STAFF REPORT - TOWN OF NORTH CASTLE PLANNING DEPARTMENT

APPLICATION NUMBER - NAME
#2023-020 – 1 Guion Lane
Site Plan, Steep Slope and Tree Removal
Permit Approvals

Proposed new 8,525 square foot home on an existing vacant lot.

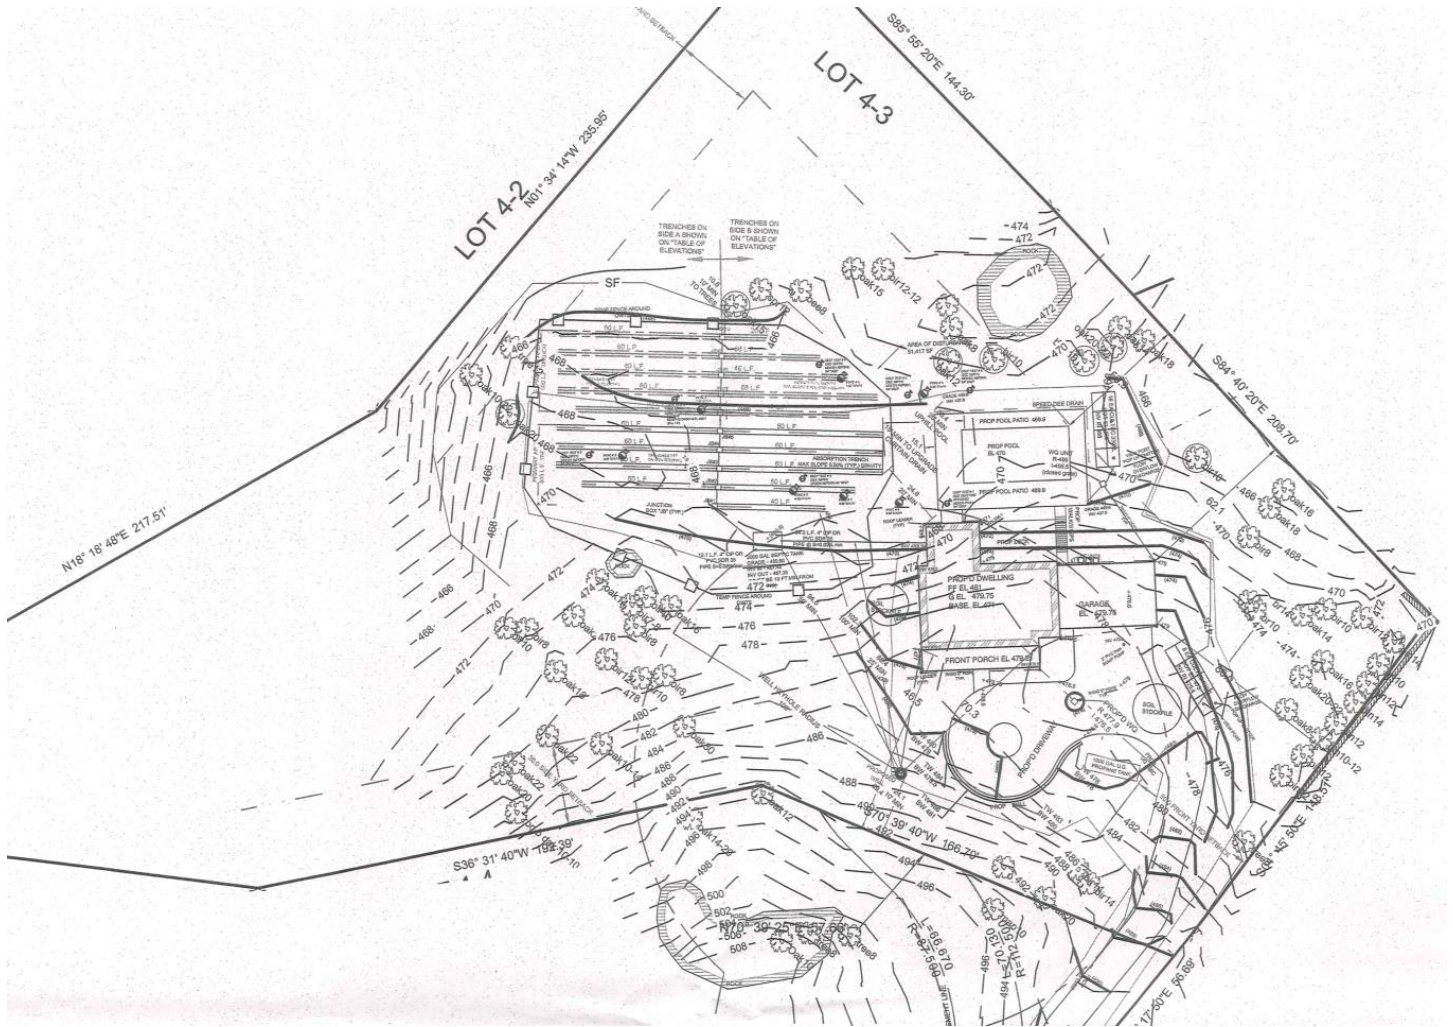
1. While the proposed house is larger than the house previously approved by the Planning Board, site impacts remain similar. The Planning Department does not have significant concern with the proposed site plan changes.

2. The Applicant should submit a steep slope exhibit and indicate whether any disturbance to Town-regulated steep slopes is proposed. If so, the Planning Board will need to issue a steep slope permit for this project.

3. The development of this lot will necessitate the removal of a large amount of Town-regulated trees, as depicted on the submitted site plan. The tree removal plan should be updated with a tree removal inventory so the Planning Board can quantify the proposed amount and type of tree removal.

5. The elevations should be revised to depict Building Height and Maximum Exterior Wall Height.
6. It is recommended that the septic expansion area not be constructed at this time. If approved by the Health Department, several Town-regulated trees can remain.

7. Portions of the proposed pool patio does not meet the rear yard setback. The pool complex should be reconfigured to comply with the setback requirements of the Town Code.

9. The Applicant should provide gross land coverage and gross floor area backup exhibits for review.
10. The site plan (SW-2) shall be revised to include a note that the septic expansion area will not be cleared and graded at this time.
